# TECHNICAL SERVICE BULLETIN

## 2020 Explorer/Aviator - Exhaust Rattle Noise

**20-2282**  
20 August 2020

This bulletin supersedes 20-2220. Reason for update: Incorrect or Incomplete Symptom

Figure 1

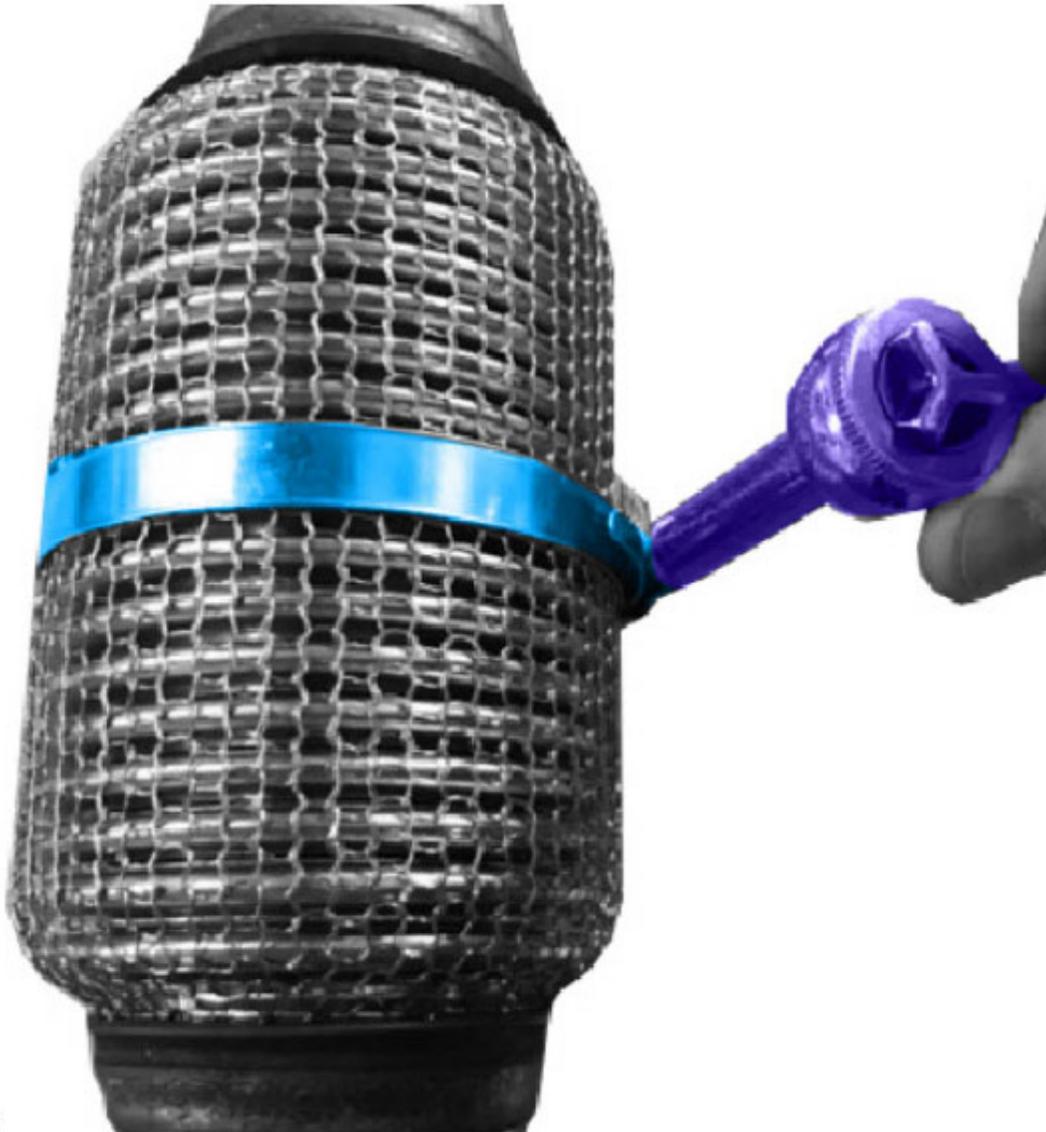
**Issue:** Some 2020 Explorer/Aviator vehicles may exhibit a rattle type noise originating from the exhaust flexible pipe. This may be due to the natural harmonic frequency of the pipe. To correct the condition, follow the Service Procedure to install a worm gear clamp over the exhaust flexible pipe.

1. Open and install the worm gear clamp over the flexible portion of the exhaust flexible pipe. Tighten to 2.7 Nm (24 lb-in) (Figure 1).
